BRICKLIGHT COURTYARDS
LOTS 6-10 AND 17-21
BLOCK 1
UNIVERSITY HEIGHTS

CITY OF ALBUQUERQUE,
IMPROVEMENTS FOR
PAVING AND WATER

AS-BUILT CERTIFICATION

I, Billy O. McCarty, NMPE 13672, of the firm BEAM Designs, hereby certify that this project has been constructed in substantial compliance with and in accordance with the design intent of the approved plans dated 07/11/07. The record information edited onto the original design document has been obtained by Michael Trujillo, NMPS 11993, of the firm. Precision Surveys, Inc. I further certify that I have personally visited the project site during construction between the dates of 02/21/07 and 01/14/08 and have determined by visual inspection that the survey data provided is representative of actual site conditions and is true and correct to the best of my knowledge and belief. This certification is submitted in support of a request for Final Acceptance.

TITLE: BRICKLIGHT COURTYARDS
HARVARD AVE. PAVING PLAN

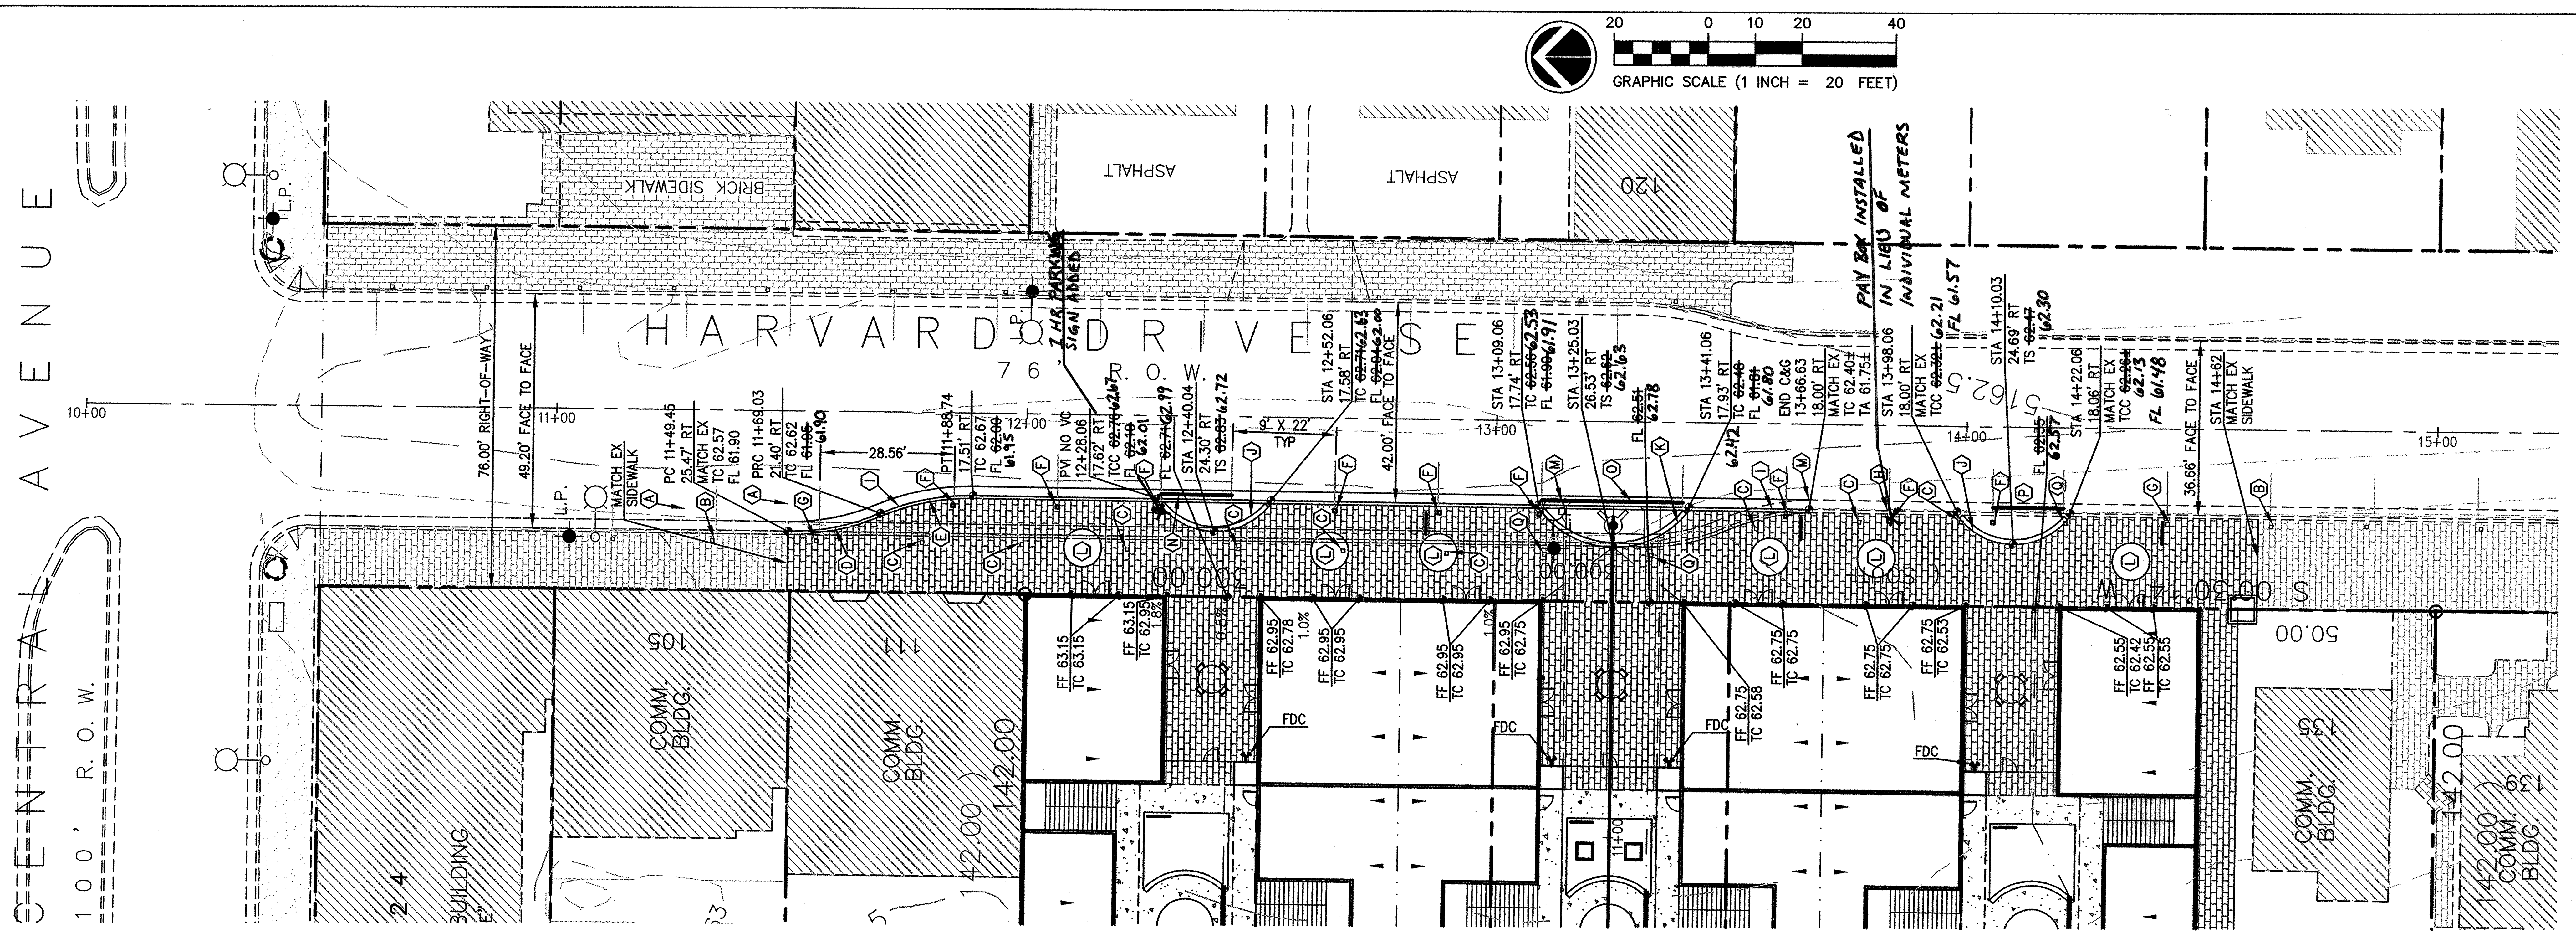
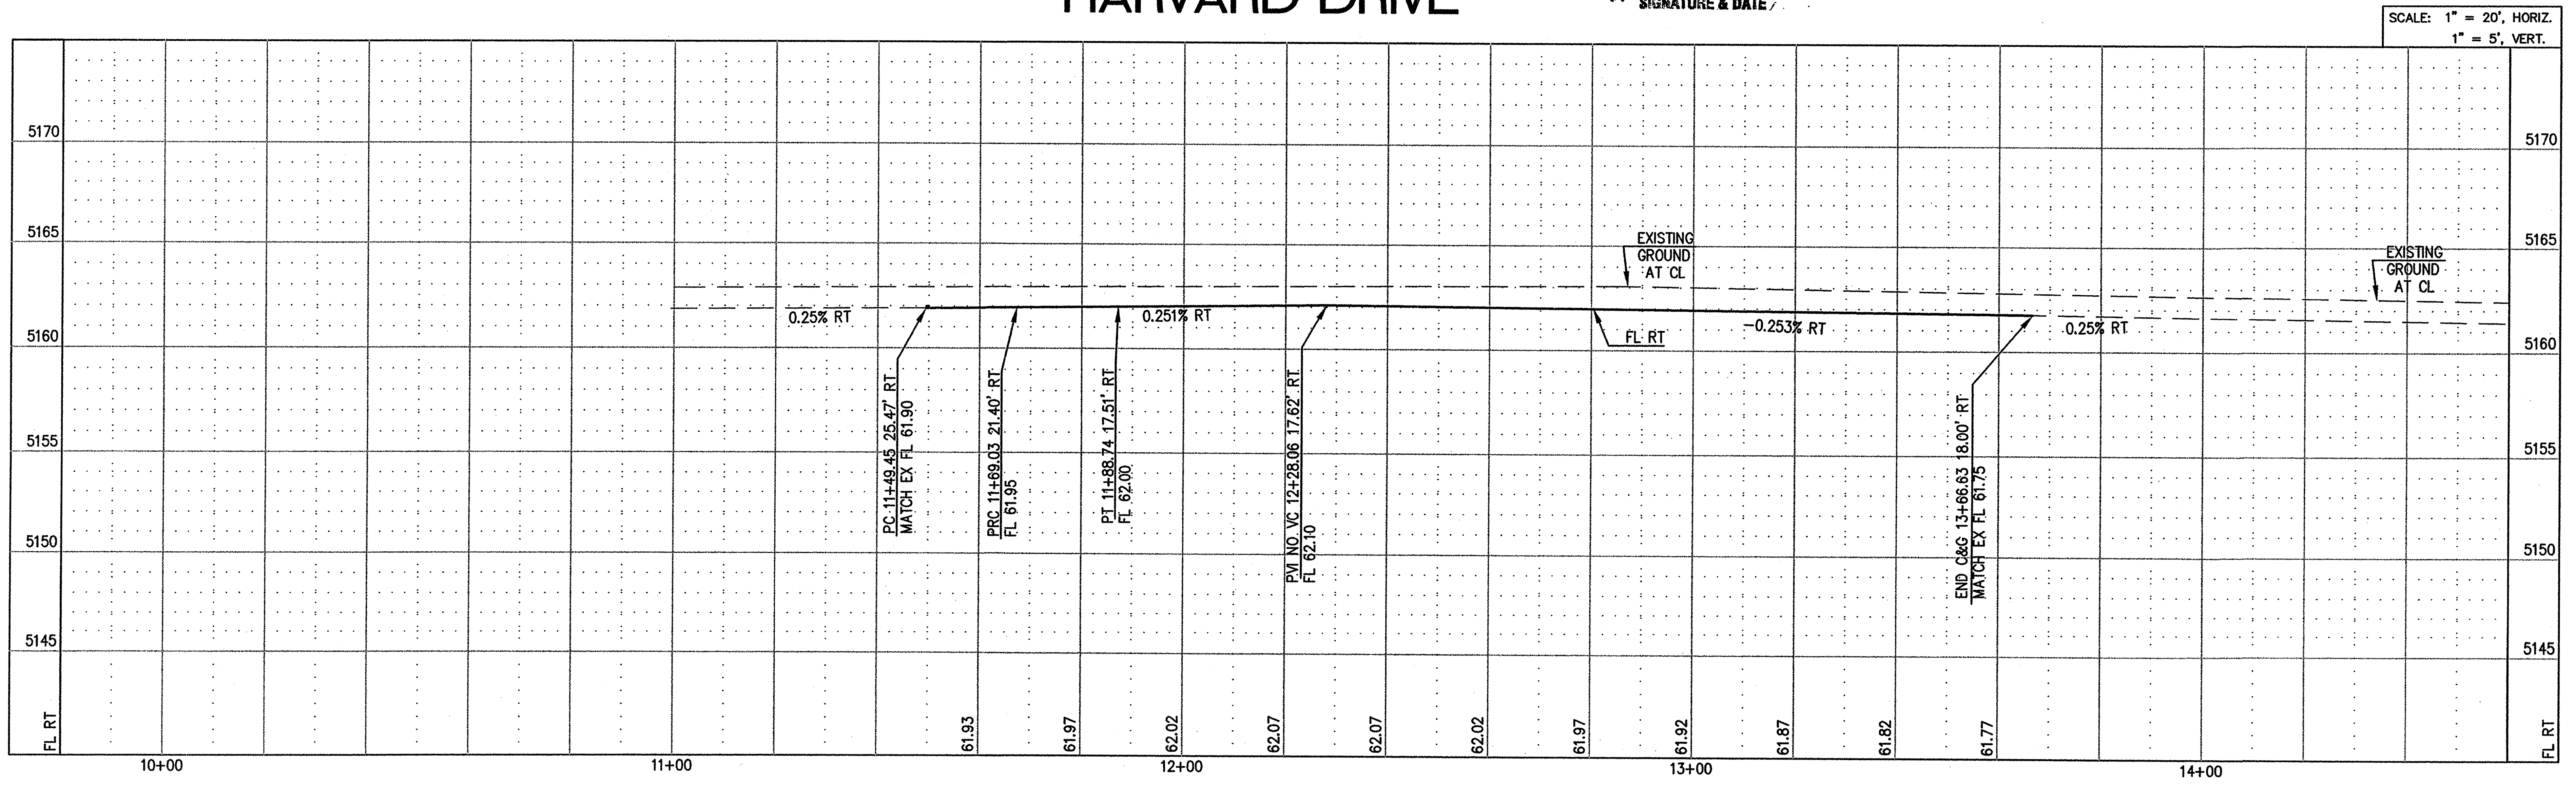
36.66' FACE TO FACE
BRICK SIDEWALK
ASPHALT
ASPHALT
120
105
111
135
139
COMM. BLDG.
COMM. BLDG.
COMM. BLDG.
COMM. BLDG.
L.P.
MATCH EX SIDEWALK
PC 11+49.45 25.47' RT MATCH EX TC 62.57 FL 61.90
PRC 11+69.03 21.40' RT TC 62.62 FL ~~61.95~~ 61.90

28.56'
PT 11+88.74 17.51' RT TC 62.67 FL ~~62.00~~ 61.95
PVI NO VC 12+28.06 17.62' RT TCC ~~62.76~~ 62.67 FL ~~62.10~~ 62.01
FL ~~62.71~~ 62.99
STA 12+40.04 24.30' RT TS ~~62.83~~ 62.72
1 HR PARKING SIGN ADDED
9' X 22' TYP
STA 12+52.06 17.58' RT TC ~~62.71~~ 62.63 FL ~~62.04~~ 62.00
STA 13+09.06 17.74' RT TC ~~62.56~~ 62.53 FL ~~61.90~~ 61.91
STA 13+25.03 26.53' RT TS ~~62.62~~ 62.63
FL ~~62.51~~ 62.78

62.42
STA 13+41.06 17.93' RT TC ~~62.48~~ FL ~~61.81~~ 61.80
END C&G 13+66.63 18.00' RT MATCH EX TC 62.40± TA 61.75±
PAY BOX INSTALLED IN LIEU OF INDIVIDUAL METERS
STA 13+98.06 18.00' RT MATCH EX TCC ~~62.79±~~ 62.21 FL 61.57
STA 14+10.03 24.69' RT TS ~~62.47~~ 62.30
FL ~~62.75~~ 62.57
STA 14+22.06 18.06' RT MATCH EX TCC ~~62.26±~~ 62.13 FL 61.48
STA 14+62 MATCH EX SIDEWALK
10+00
11+00
12+00
13+00
14+00
15+00
FF 63.15 TC 63.15
FF 63.15 TC 62.95
FF 62.95 TC 62.78
FF 62.95 TC 62.95
FF 62.95 TC 62.95
FF 62.95 TC 62.75
FF 62.75 TC 62.75
FF 62.75 TC 62.58
FF 62.75 TC 62.75
FF 62.75 TC 62.53
FF 62.55 TC 62.42
TC 62.55 TC 62.35
FDC
FDC
FDC
FDC
5162.5
S 00°30'24" W

~~F. NEW LOCATION FOR EX. PARKING METER.~~

~~G. EX. PARKING METER TO BE REMOVED AND RELOCATED TO SAME LOCATION.~~

~~Q. REMOVE PARKING METER AND RETURN TO CITY OF ALBUQUERQUE.~~

TITLE: BRICKLIGHT COURTYARDS
ALLEY PAVING PLAN

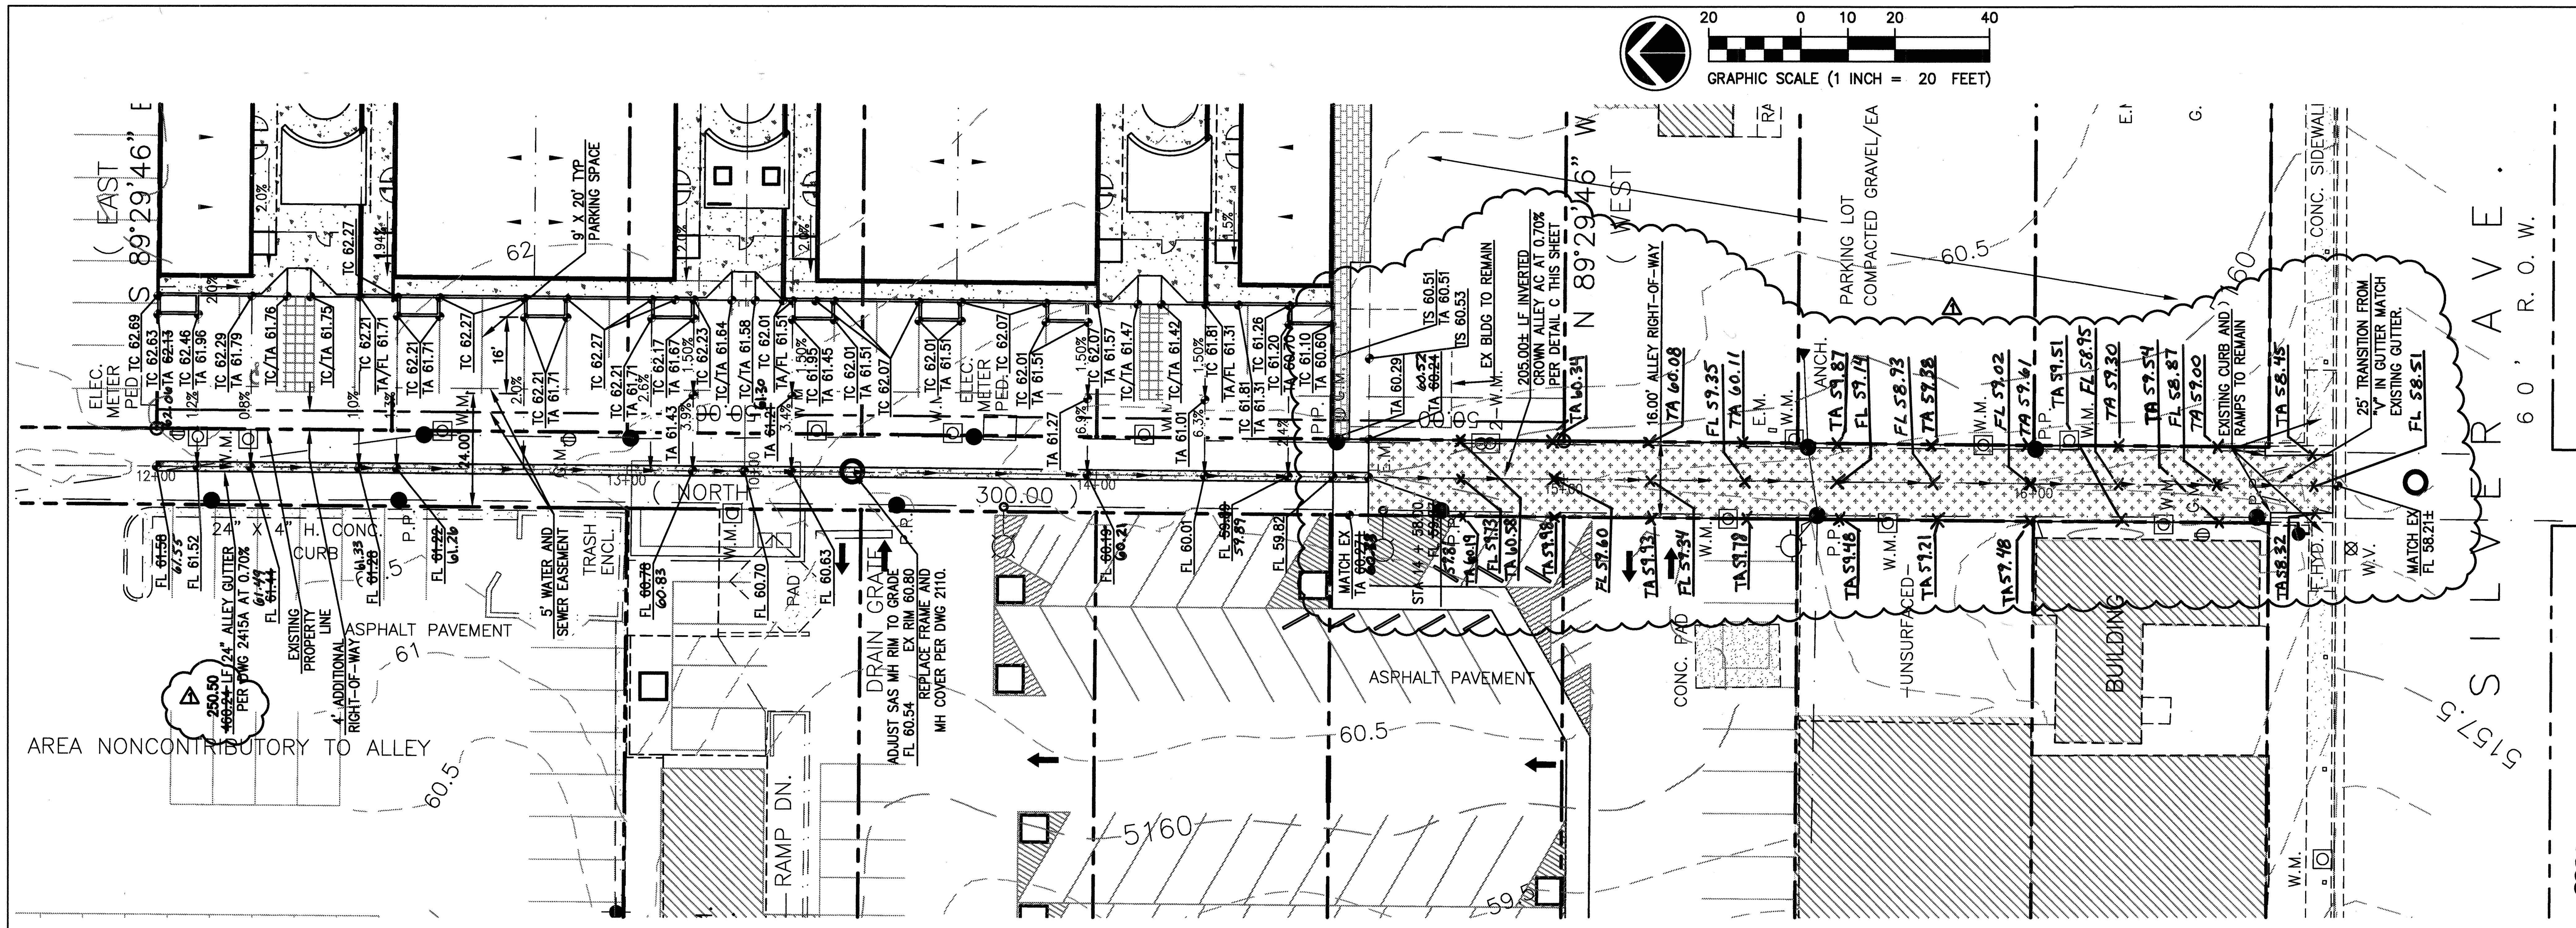
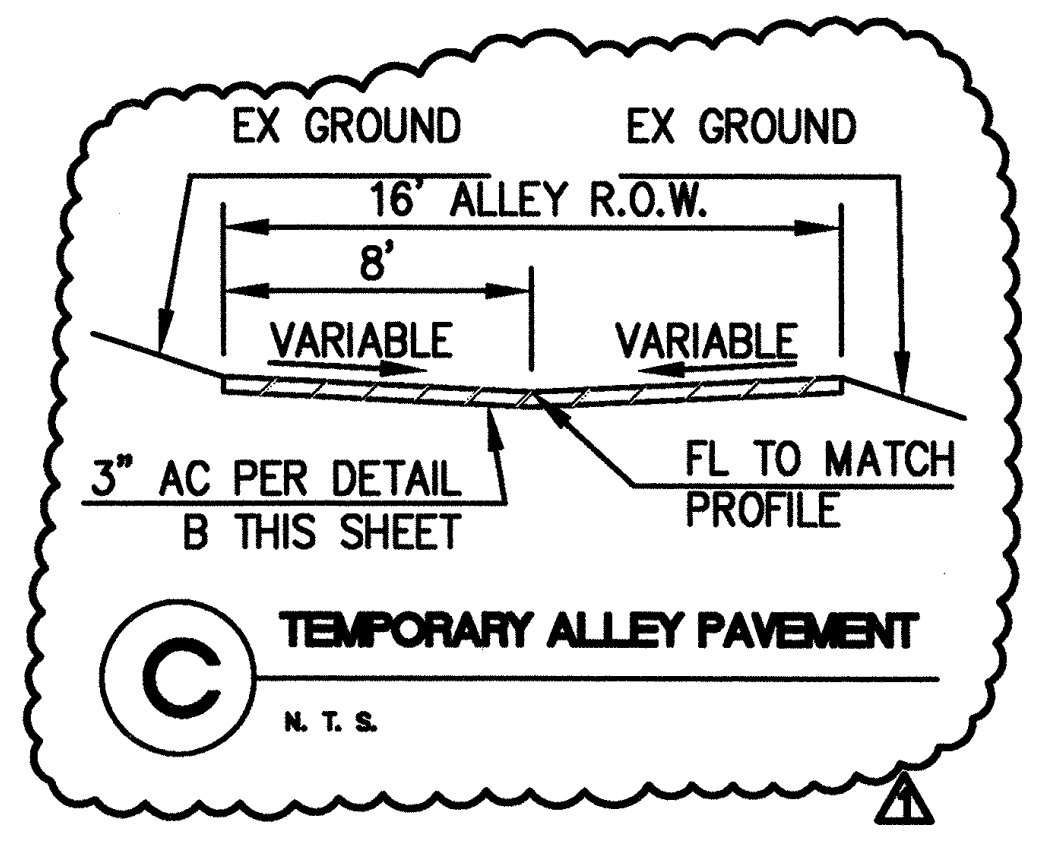
NO.	DATE	REMARKS	BY
1	9/25/08	ELIMINATED GUTTER FROM S. 1/2 OF ALLEY	BOM
